# **Report on Duke Energy Indiana's 2021 IRP**

**Submitted to the IURC on May 16, 2022**

**On behalf of Citizens Action Coalition, Earthjustice, and Vote Solar**

**Figure 1. Gas Price Forecasts Presented During 4<sup>th</sup> Stakeholder Workshop<sup>2</sup>**

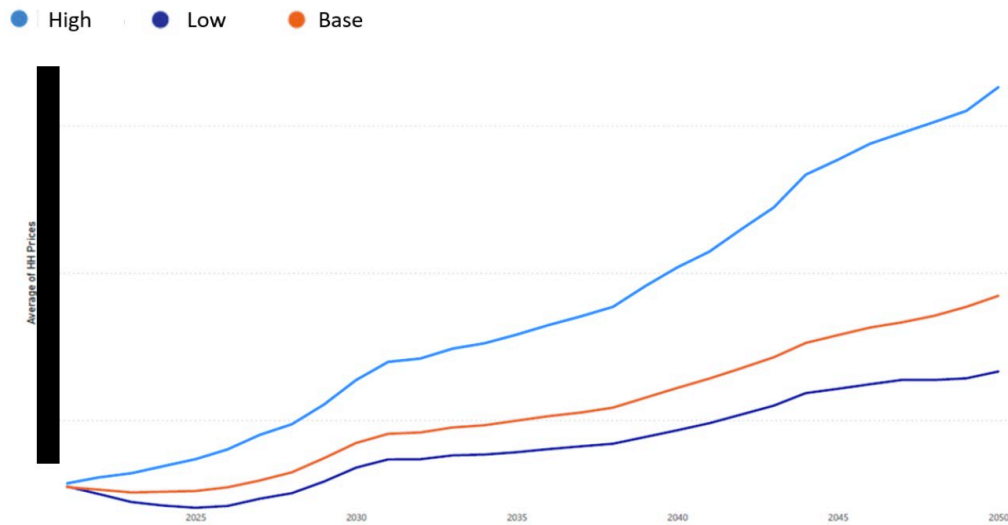
- The level of information presented at the stakeholder workshops was frequently not deep enough to engage more technical stakeholders. For example, during the 4<sup>th</sup> stakeholder workshop, the following graph of Duke’s gas price forecasts was presented with the y-axis redacted, conveying no meaningful information except that prices will increase, but it was impossible to tell at what rate or how those prices compare to other gas price forecasts:

**Figure 5. Duke Energy Forecasts (GWH)**

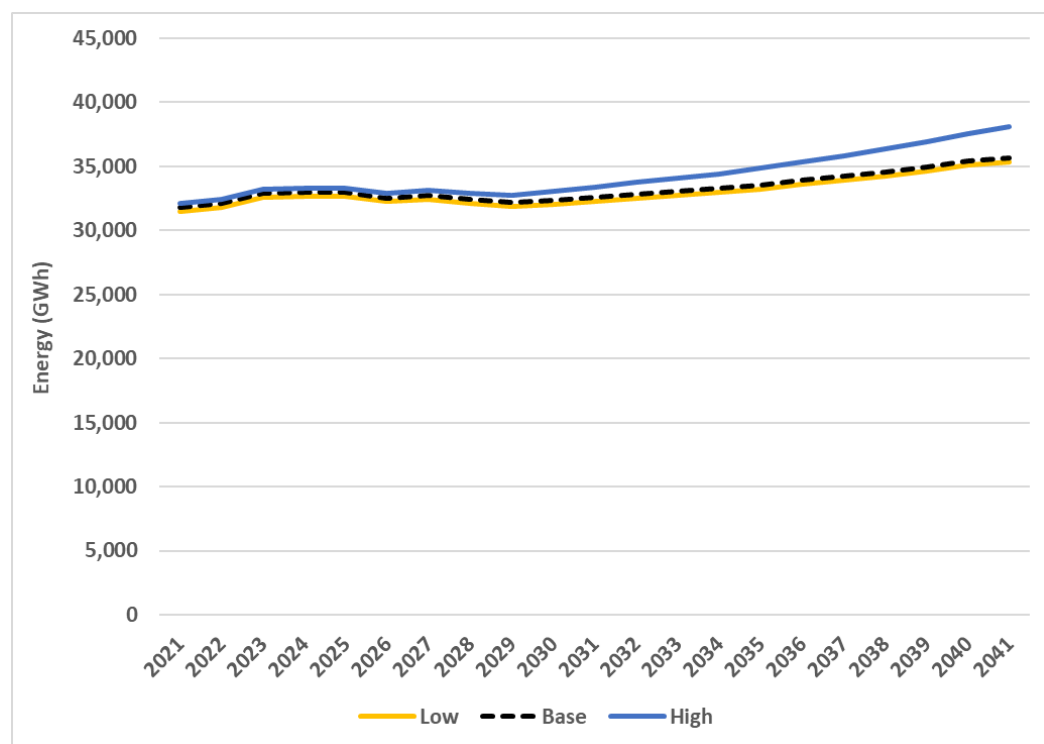
Figure 5 and Figure 6 show Duke’s energy and peak demand forecast for the low, base, and high forecasts, respectively. Duke has a near term spike in energy and demand from the addition of new wholesale customers.<sup>23</sup> The forecasts then drop nearly 500 MW<sup>24</sup> due to the loss of customers between 2025 and 2028.<sup>25</sup>

Figure 7. Annual Percentage Difference in Base and Low Peak Forecasts

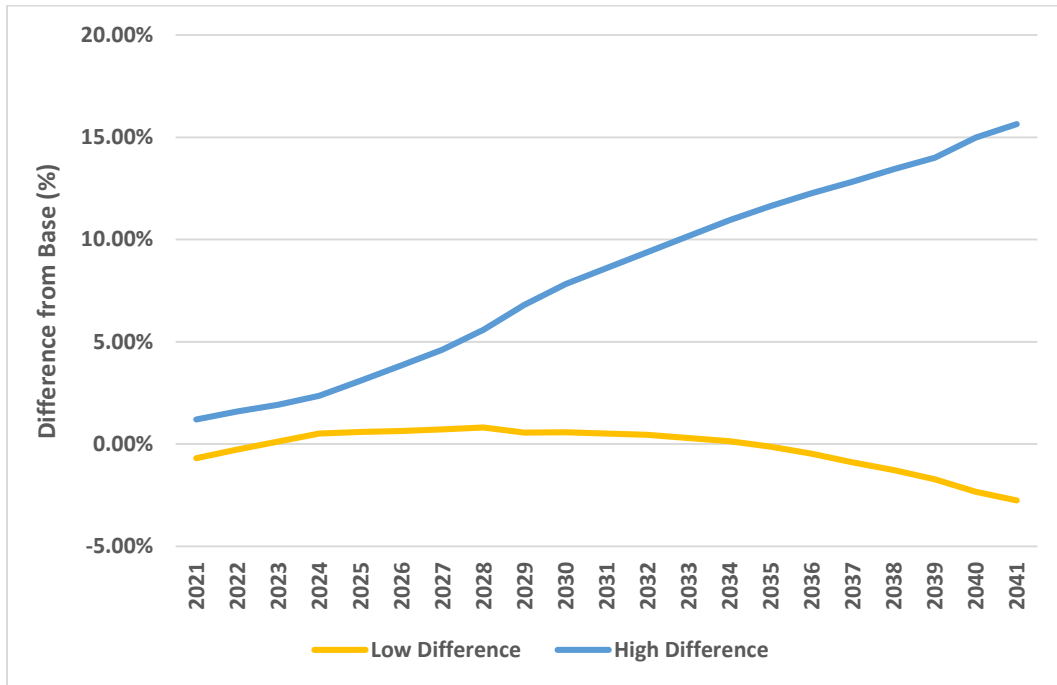
Figure 7 shows the annual percentage difference between the base and low forecasts compared to the base and high forecasts. While we would not expect to see the same difference in growth rate between the base and high forecasts and the low and base forecasts as it is our understanding that the high case assumes higher levels of electric vehicle penetration, the difference between the low and base is almost negligible, severely limiting the usefulness of the low forecast sensitivity. As is clearly evident from Figures 5, 6, and 7, the low forecast does not capture much downside risk to Duke’s load forecast. For example, Duke could create a forecast that captures the risk of further loss of wholesale load.

**Figure 8. Gross Generation at Noblesville CC Unit 5 during PST Winter Period**

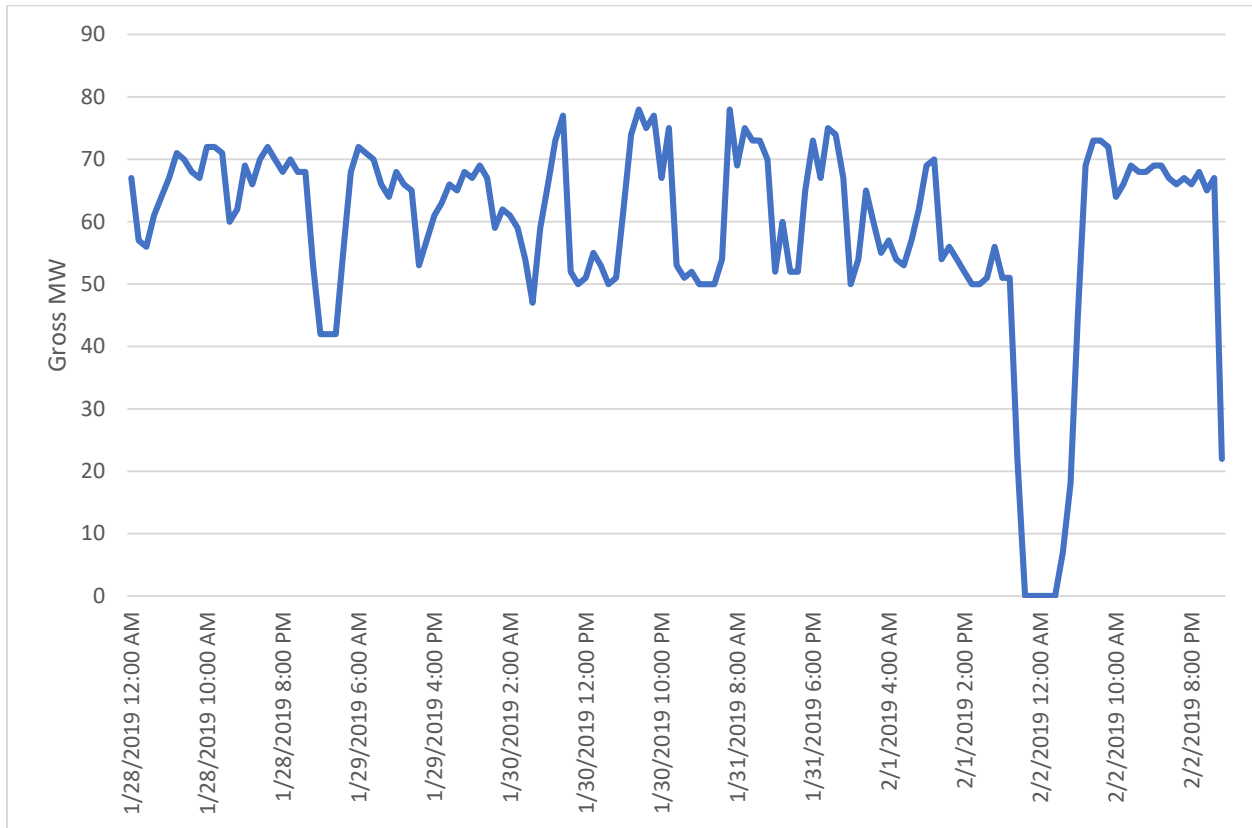
Another concern with the PST is how realistically it represents the dispatch of thermal generators. Duke's generators are offered into MISO, and but for Duke's self-commitment practices, it is MISO that determines whether to commit and dispatch those units. Also, Duke seems to be ignoring the likelihood of correlated failures.<sup>38</sup> For example, the tool appears to assume that Duke's combined cycle unit, Noblesville, operated at full output or 310 MW for the entire winter period. The reality, however, was different. Hourly data from one of the combustion turbines at the plant show frequent dispatch downward and upward as well as a period in which the unit appeared not to operate at all (the reasons for this are unknown) as shown in Figure 8.

**Figure 9. Cayuga Unit 1’s Actual Gross Generation during PST Winter Period**

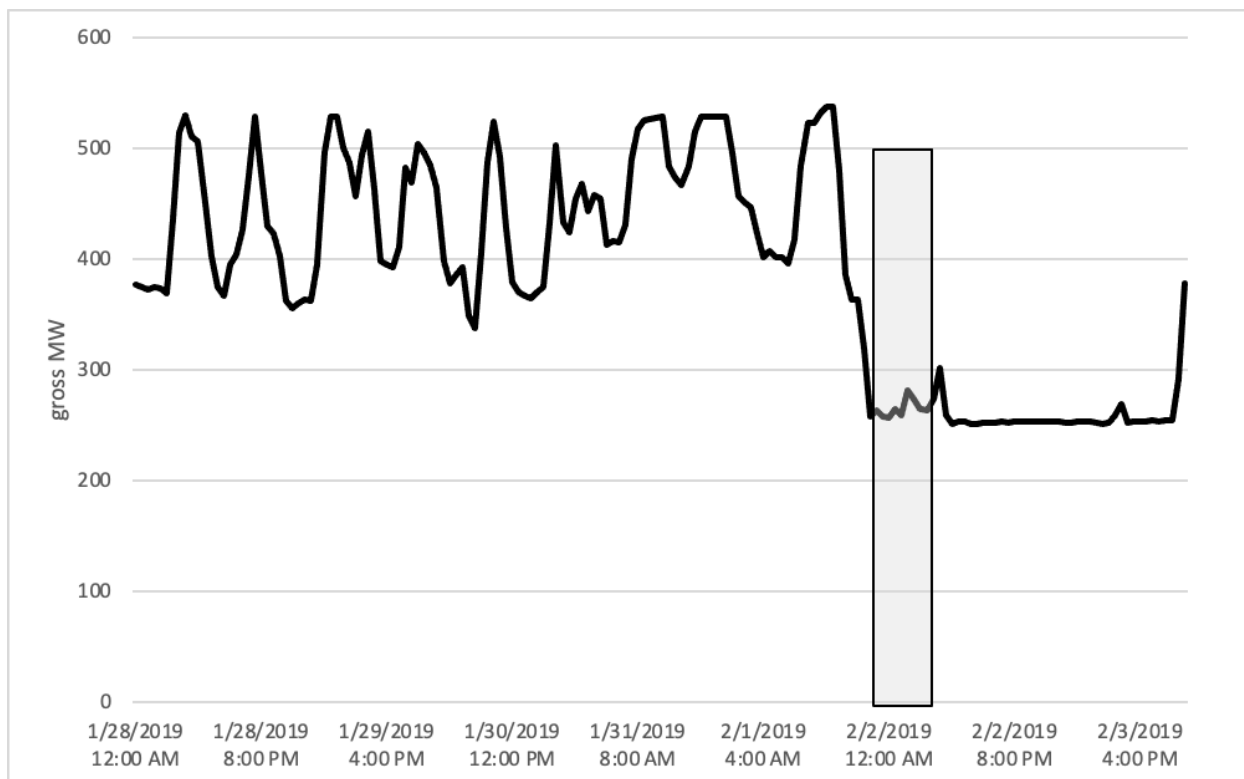
The PST also appears to be overstating the performance of Duke’s coal fleet. For example, during the period from 0:00 to 9:00 hours on February 2, 2019, the tool assumes that all of Duke’s coal fleet is operating at full load or 4,748 MW. That period is shaded in grey in Figure 9, below.

Again, the reality was different. For example, Cayuga Unit 1, shown in Figure 9, was dispatched downward close to what appears to be its minimum loading level during this period. The reasons for this are unknown. This could be because it was economic to dispatch the unit downward, because of a partial derating of the unit, or for some other reason.
